PEPC Project ID: 58434, DocumentID: 80871

This letter concerning the proposed WWI memorial on the site of Pershing Park in Washington, D.C. serves as an addendum to the one we sent on June 20, 2017. It is prompted by material provided to the Section 106 Consulting Parties at the June 28, 2017 meeting, specifically the WWI Centennial Commissions presentation and the excel spread sheet titled, Historic Preservation Resource Summary. We are grateful to have this detailed spread sheet of adverse effects in our quest to gain a better understanding of the WWI Centennial Commissions current proposal, the Restored Pool Concept, which is, in fact, not a restoration, by any standard or definition.

Correspondences - Design and Develop National World War I Memorial - PEPC ID: 58434

Exhibit A

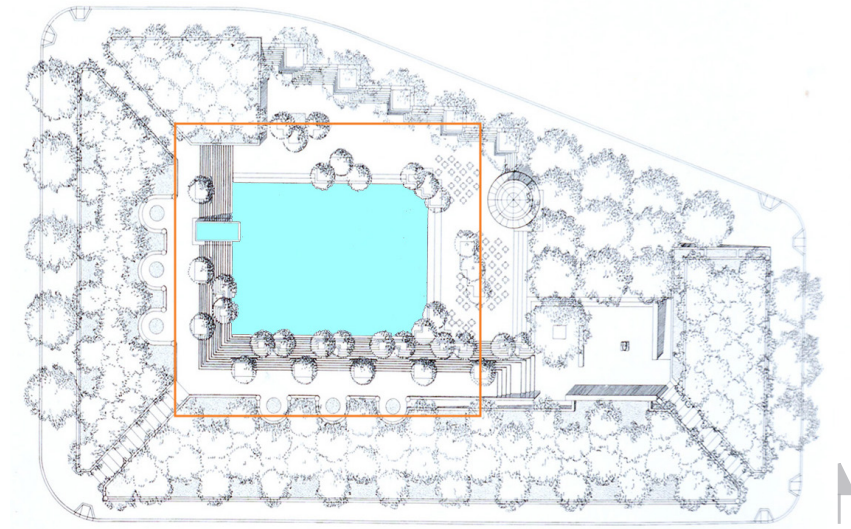
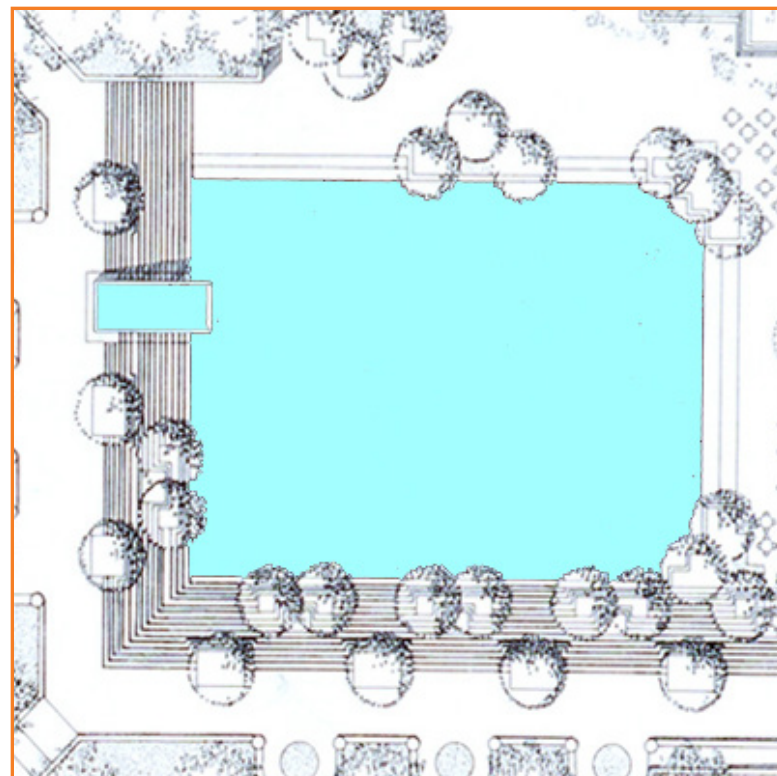
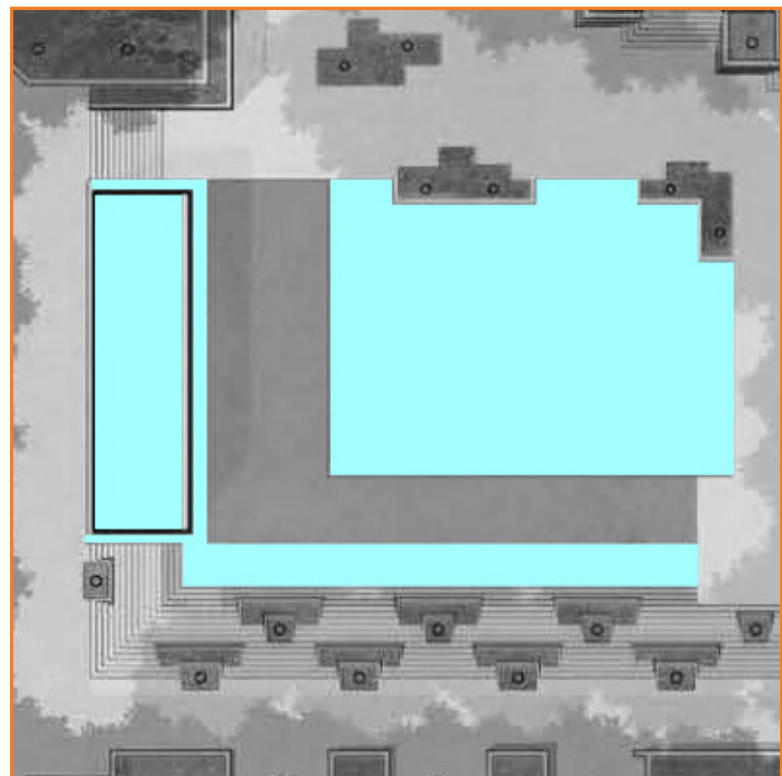
Regarding the pool, which is labeled as “restored,” the adverse effect is significant (for a comparison see Exhibit A as an Appendix to this letter). A new “L-shaped” path would be inserted within the pool’s existing footprint, reducing the pool’s surface area by some 40%, since the water would be replaced with hardscape. The depth of the remaining pool areas surrounding this new hardscape is ill-defined; it’s unclear whether the current depth will be maintained or would become a scrim or a combination of the two (for example, the walk area to the south of the pool basin, is shown dry in the rendering on page eleven, wet in the rendering on page fourteen, and shallow in the axonometric on page twelve). Whichever way, the integrity of the pool is significantly diminished. Moreover, according to the site plan of the proposed memorial, steps that currently lead down to the pool on the northern and eastern sides would be eliminated. By definition, that is not restoration.

In addition to the loss of some 40% of the pool surface, the removal of the existing fountain is more than a physical loss; it impacts the integrity of Friedberg’s design, especially the “feeling” that it conveys. The fountain in Friedberg’s Pershing Park was not only aesthetically pleasing and commanding, it was designed to mitigate noise (from the surrounding vehicular traffic); have a cooling effect (from the mixing of air and water resulting during evaporation); and serve as a place of respite in the center of the city, offering opportunities for recollection, contemplation and remembrance, or, as Friedberg noted, “where the topography and the viewer came to rest.” The proposed wall, more than six times the length of the existing fountain, only provides small areas along its sides along which water would sheet down. This is a substantial change from the more exuberant cascade that mitigated noise and provided a cooling effect.
